**From:** Nicholas Scott [REDACTED]  
**Sent:** 18 February 2022 11:25  
**To:** Simon Davis <[Simon.Davis@arun.gov.uk](mailto:Simon.Davis@arun.gov.uk)>  
**Subject:** RE: Y/19/22/DOC Approval of details condition 4 under Y/89/14/PL ref PRow (FP200/2)

Further to your comments on this application, please see below response from the planning agent. Can you advise whether your request for further information still stands?

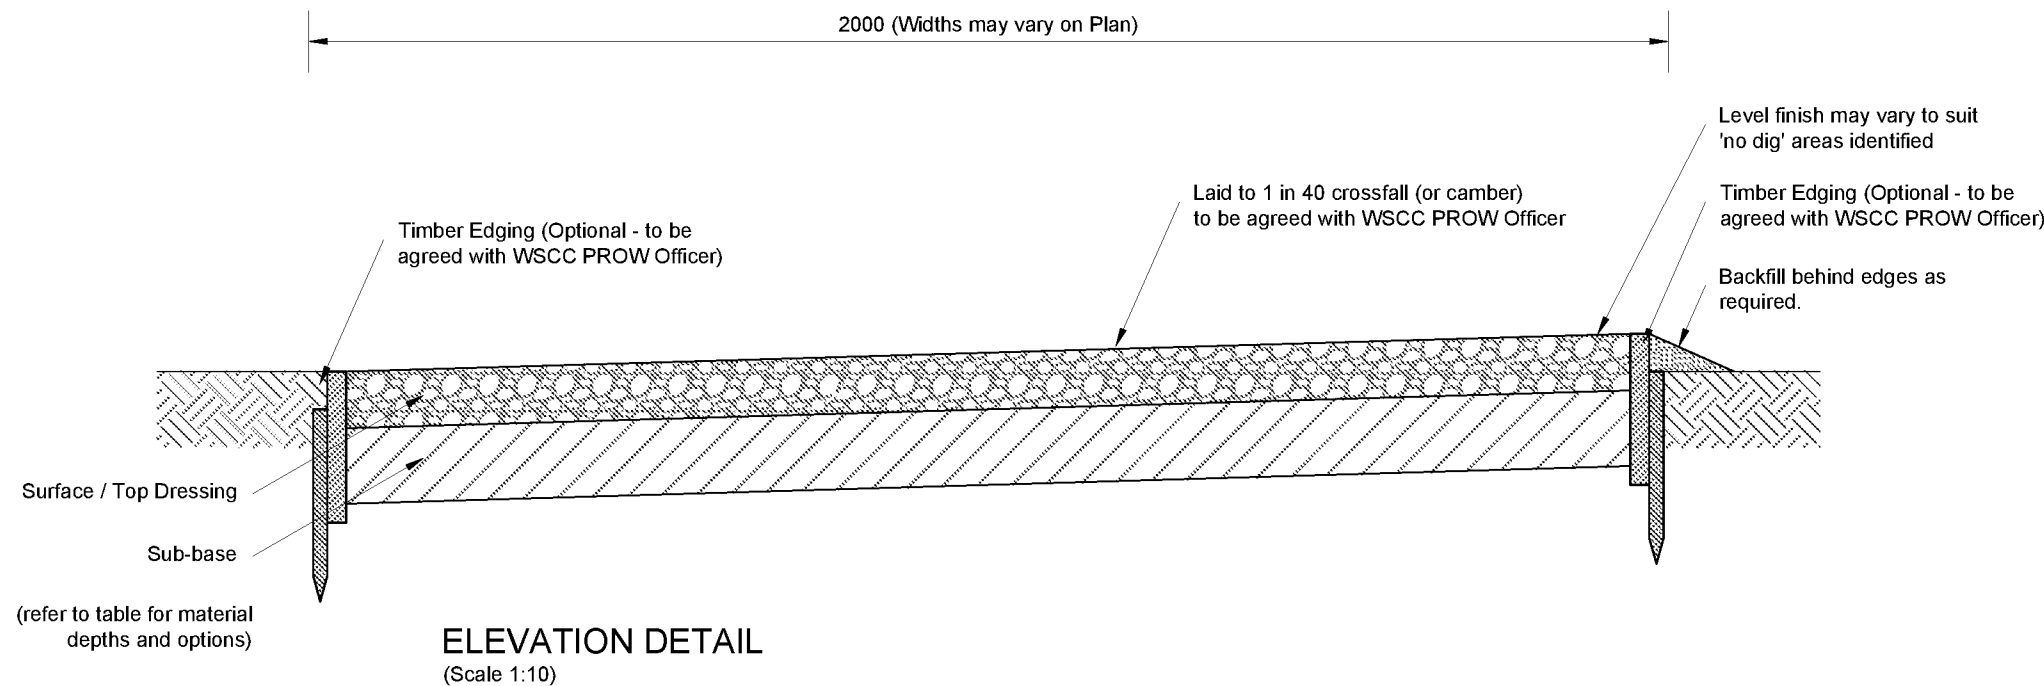
I can confirm the feature that the Officer advises may be a road are actually power lines.

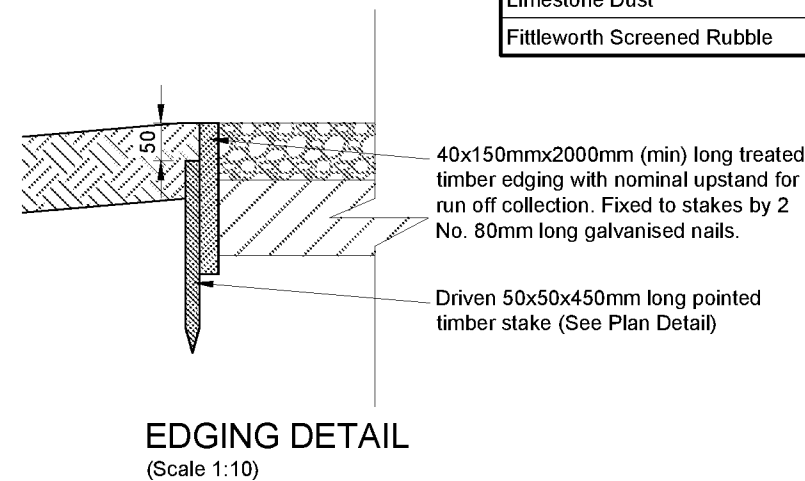
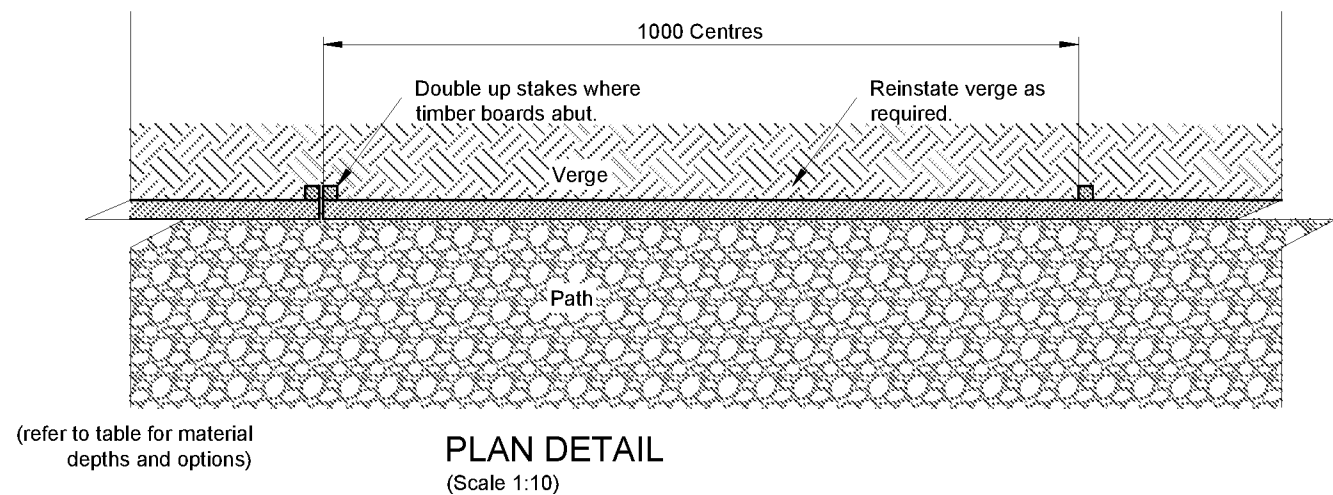
This additional information is helpful and in main does satisfy my query and provides the information I require. The only change I would suggest would be the specification for the surfacing of Countryside footpath and I see reference to eco-mix. Due to issues with this surface in the past we have now moved away from this material and attached is a standard specification for a footpath and the most appropriate surface would be Option B in the "FOOTPATH - Alternative Construction Types". If the document could be changed to reflect this then I have no objection the proposals and the additional information request is considered satisfied from my perspective.
